Construction Method Statement.

Planning Application for the laying of underground electricity cables in association with Monksfield Solar Farm (LPA Reference: M/24/01781/FUL).

Date: August 2025 | Pegasus Ref: P20-0137 TR03

Version	Date	Author	Checked/ Approved by:	Reason for revision
TR03	August 2025	LT	KS	-
TR04	28 th August 2025		PPLAN on behalf of Pegasus	PPLAN have added an executive summary and some explanatory notes for the benefit of planners and others

Cable Routing

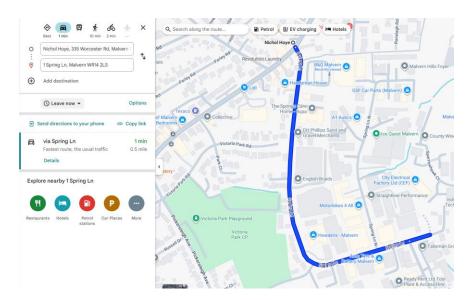
You may of course think that the thing that looks like a sub-station on Spring Lane is more than 80 metres along Spring Lane. Indeed, if you think it is the facility shown in the photo below, then you would be right:

If it is indeed the correct facility, then google maps shows it as half a mile from the A449 junction, as shown below:

However, by making out it is only 80m along Spring Lane, we are hoping that planners will not take into account all the disruption to local businesses etc whilst we are digging up the road and parking our big lorries along the road.
